STAFF RECOMMENDATION
1303 Stratton Avenue
April 19, 2019

Application: New Construction—Addition; Partial Demolition
District: Lockeland Springs-East End Neighborhood Conservation Zoning Overlay
Council District: 06
Base Zoning: R6
Map and Parcel Number: 08305028800
Applicant: Cheyenne Smith
Project Lead: Melissa Baldock, melissa.baldock@nashville.gov

Description of Project: Application is to construct a rear addition and to demolish a non-contributing part of the house.

Figure 2 (left) shows the front porch enclosure that is to be removed. Figure 3 (center) is the 1914 Sanborn Map and Figure 4 (right) is the 1951 Sanborn Map.

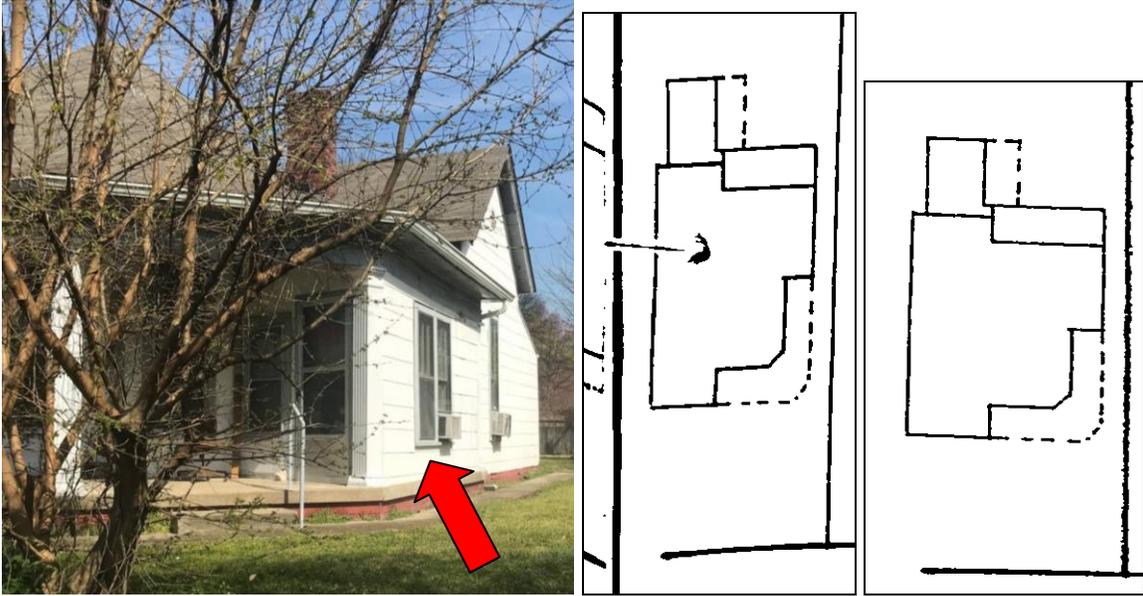
Demolition: Several aspects of the project constitute partial demolition, although staff finds them all to be appropriate. First, the applicant intends to remove a non-historic enclosure of the front porch on the right side and to restore the original size and configuration of the porch (Figure 2). The historic Sanborn maps show that the porch originally extended more into the right side than it does now (Figure 3 & 4). When the side porch was enclosed is not known, but it was sometime after the late 1950s, according to the Sanborn Maps. Since removing the enclosure will restore the original size and configuration of the porch, staff finds that this partial demolition meets the design guidelines.

02 DEMOLITION PLAN

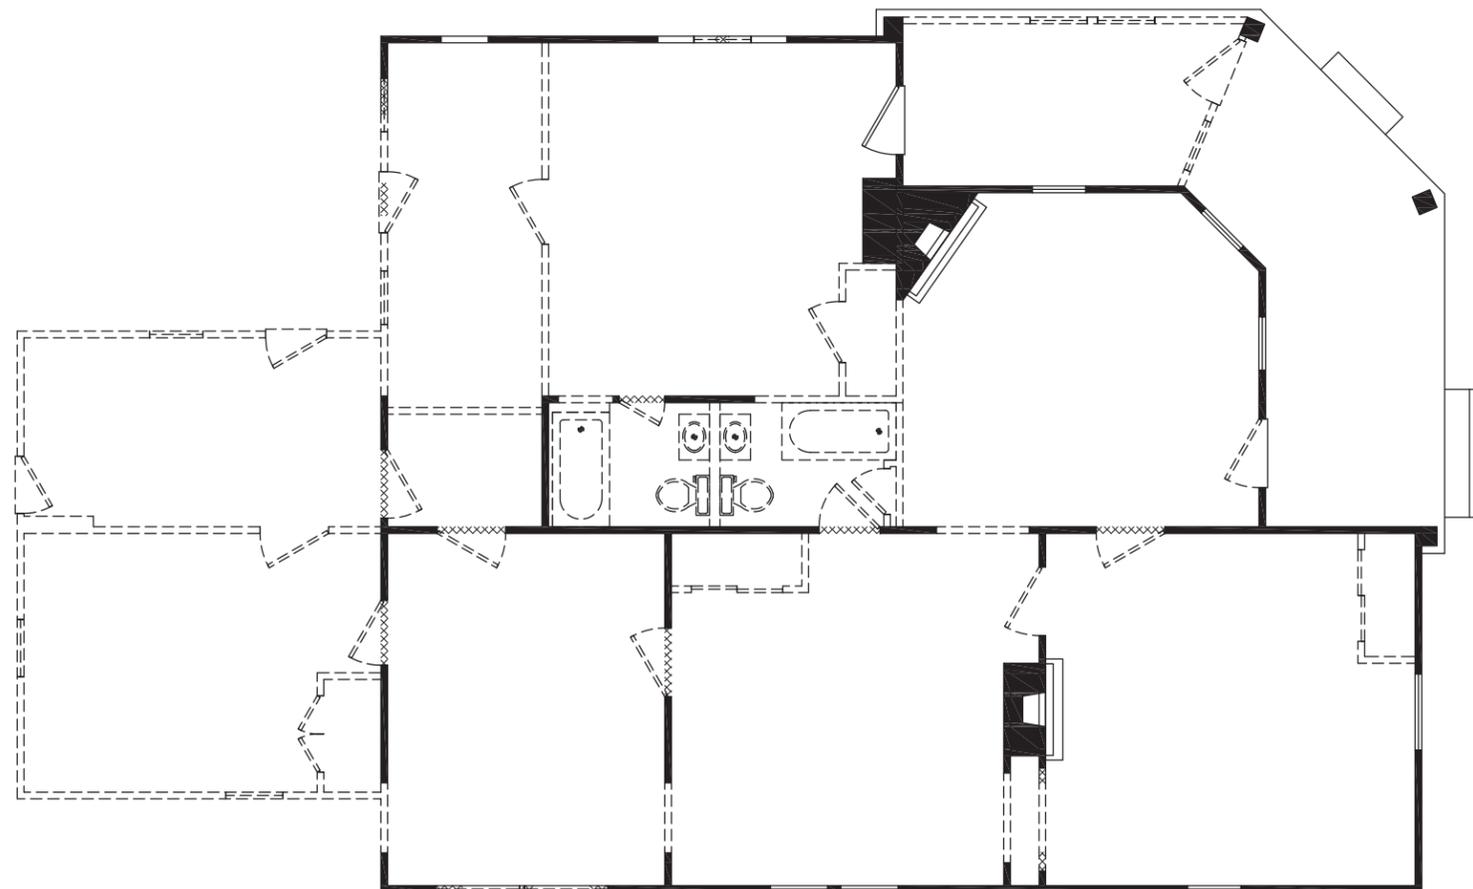
The applicant also intends to remove a section of the rear of the house that has a separate, lower roof form (Figures 5 & 6). This section of the house does appear on the 1914 and 1951 Sanborn Maps (See Figures 3 & 4). However, in looking at this rear portion of the house, staff finds that it is more utilitarian in nature and that its removal would not affect the historic character of the house.

The applicant also proposes to alter some window openings on the side facades, which is considered partial-demolition. On the left façade, towards the back, the applicant intends to enlarge a window opening which does not appear to be historic (Figures 7 & 8). Staff finds this to be appropriate because the existing window opening is not historic and the new window opening is a pair of double hung windows that match the size of the window opening to the right. Also, this window change occurs at the back of the house, where it will not be highly visible from the street. On the right façade, towards the rear, the applicant intends to make a single window opening in to a paired opening and to add a smaller window opening. Again, staff finds these changes to be appropriate because they

Staff finds that the proposed removal of the porch enclosure, the removal of the rear parts of the house, and the alteration of the window openings on the side façade are appropriate and do not alter the historic house’s architectural and historic integrity. Staff therefore finds that the proposed partial demolition meets Section III.B.2 for appropriate demolition and does not meet section III.B.1 for inappropriate demolition.

EXTERIOR
ELEVATIONS

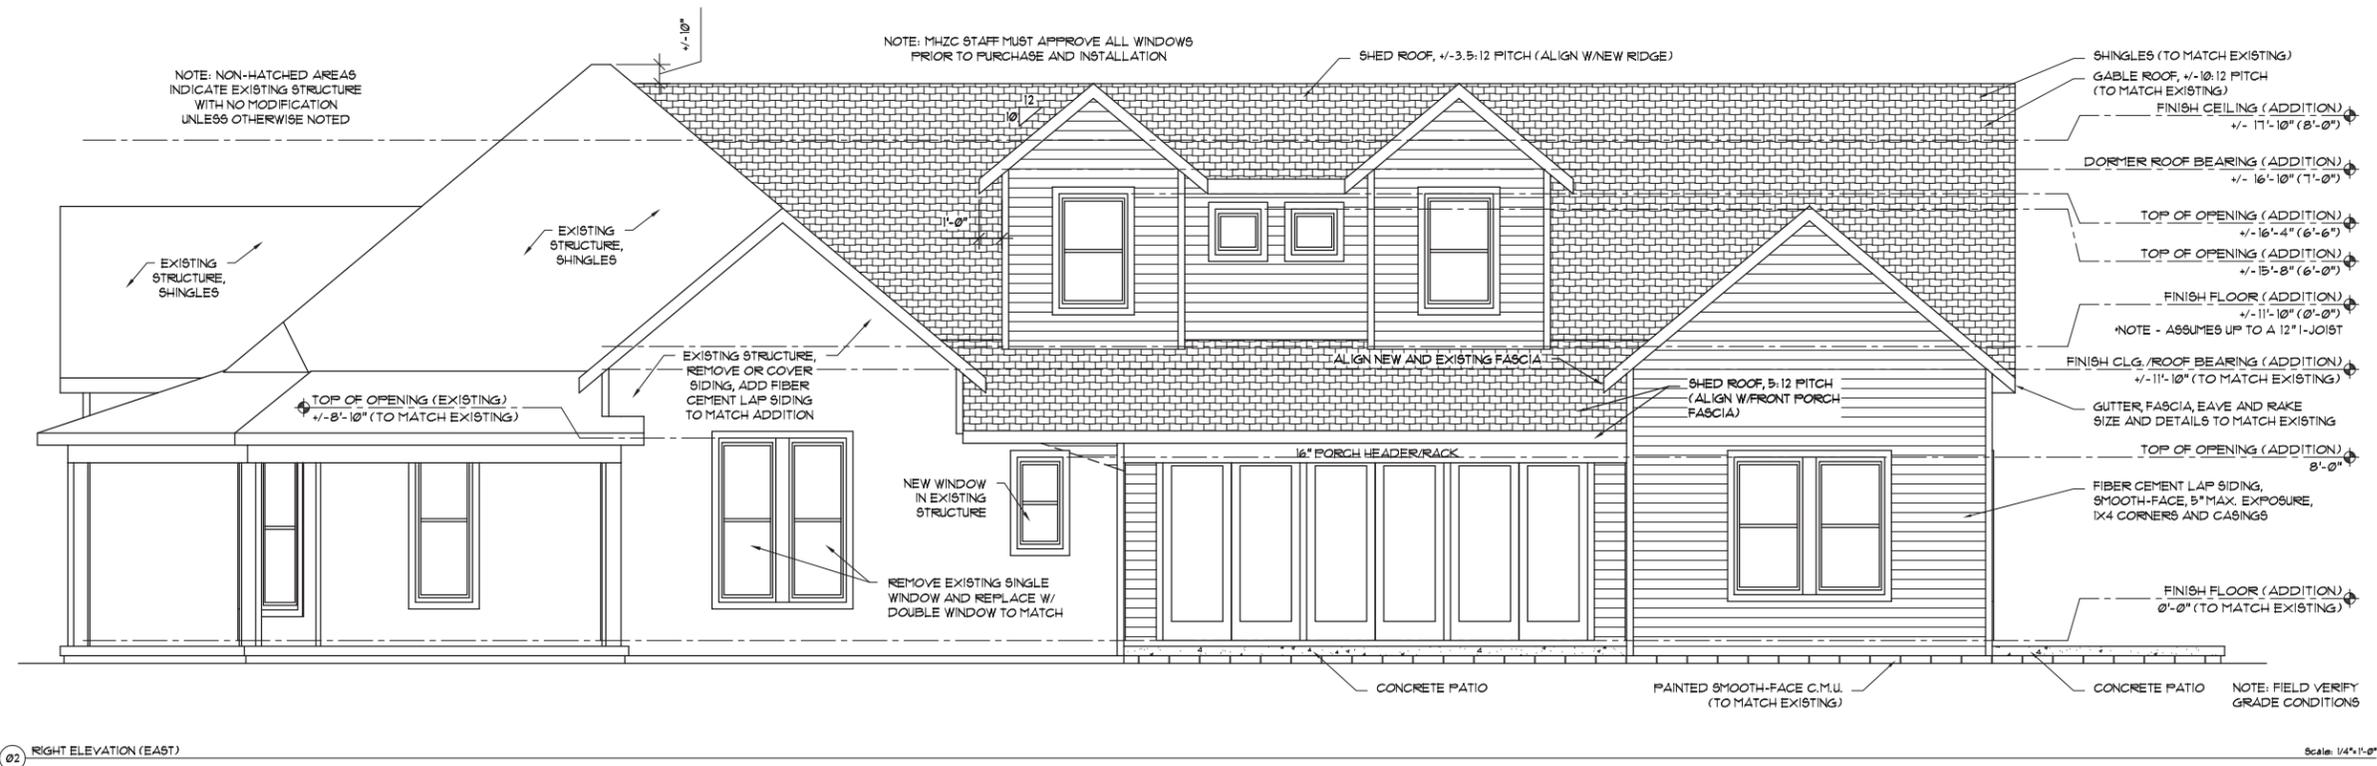
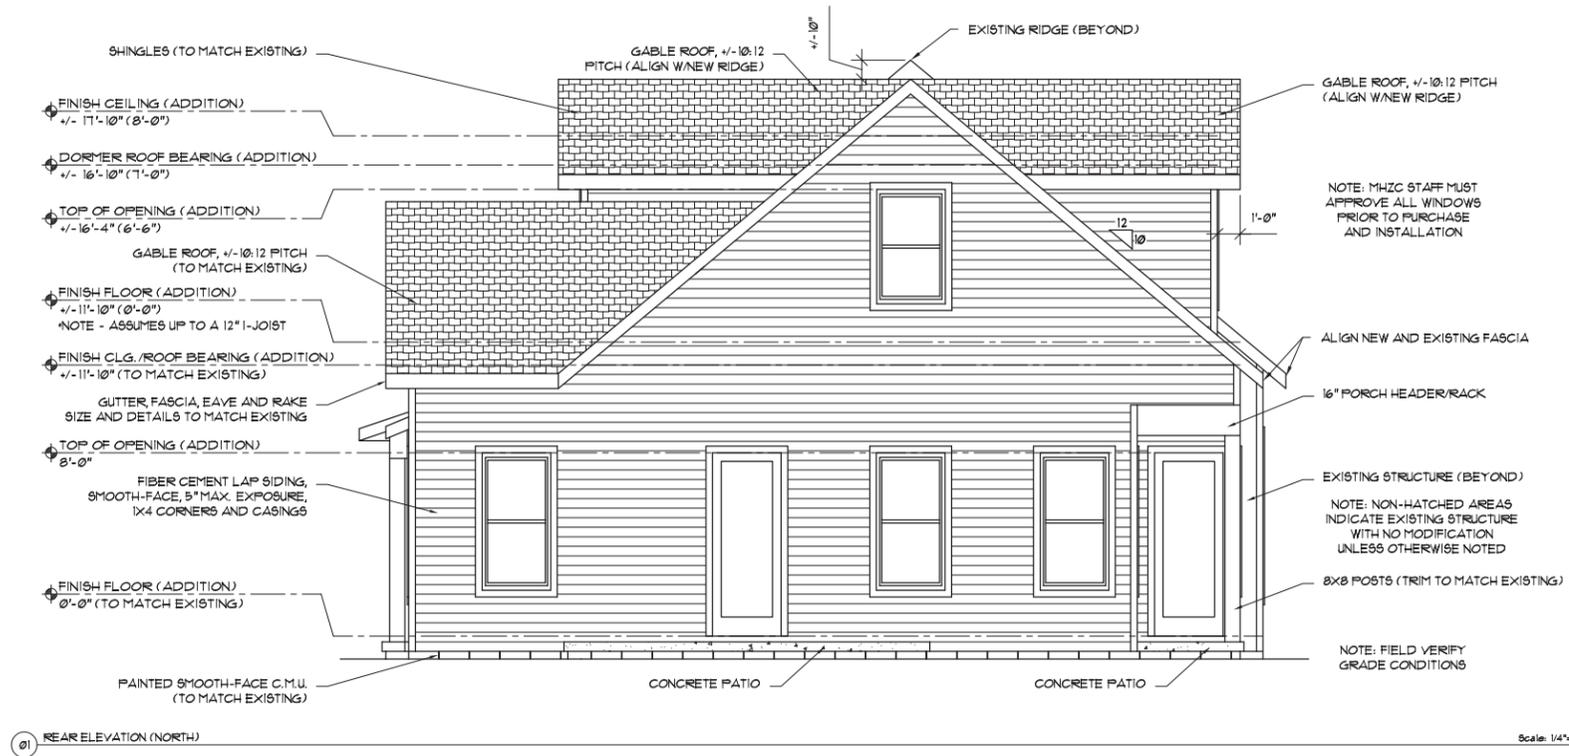
Height & Scale: The addition will be no taller and no wider than the historic house, and its eave and foundation lines will match those on the historic house. On the left façade, the addition is inset one foot (1’) for its entire depth. On the right façade, the wall of the

addition is inset seven feet, six inches (7'6") from the back corner of the house for a depth of twenty-two feet (22'), after which the addition steps back out to line up with the main wall of the historic house. The addition is one-and-a-half stories, with dormers on the roof. The dormer on the left façade is inset two feet (2') from the main wall of the historic house, while the dormer on the right side is inset seven feet, six inches (7'6") from the main wall of the historic house. The addition will not more than double the footprint of the historic house.

Roof form: The addition has a cross gable roof form with a 10/12 slope to match that of the historic house. The gabled dormers connected with a shed roof form have been approved by the Commission in the past. As noted previously, the dormers are inset appropriately.

Proportion and Rhythm of Openings: The changes to the window openings on the historic house were discussed under “Partial Demolition.” The windows on the proposed addition are all generally twice as tall as they are wide, thereby meeting the historic proportions of openings. There are square window openings in the shed connectors of the dormers. Since this portion of the addition is inset from the historic house, they will not be highly visible from the street. There are no large expanses of wall space without a window or door opening.

EXTERIOR
ELEVATIONS

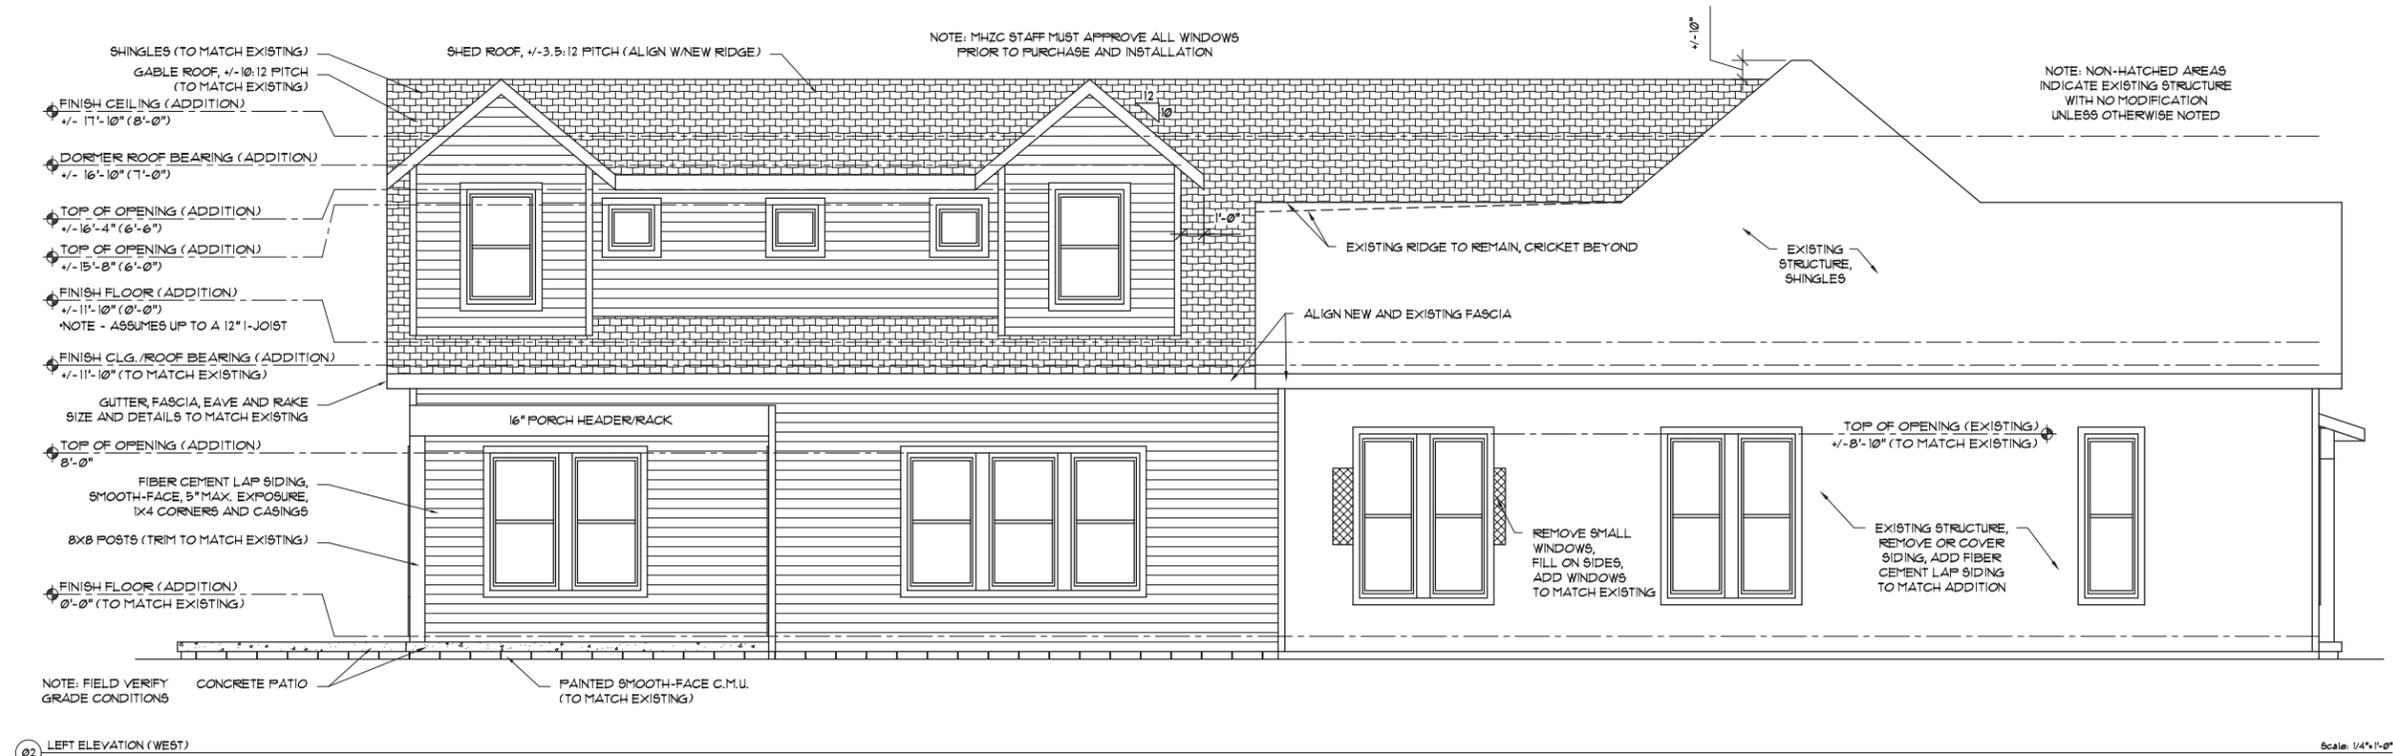
Appurtenances & Utilities: No changes to the site’s appurtenances were indicated on the drawings. The location of the HVAC and other utilities was also not noted. Staff recommends that the HVAC be located on the rear façade, or on a side façade beyond the midpoint of the house.

1. Staff approve all windows and doors and the roof shingle color prior to purchase and installation; and,
2. The HVAC be located behind the house or on either side, beyond the mid-point of the house.
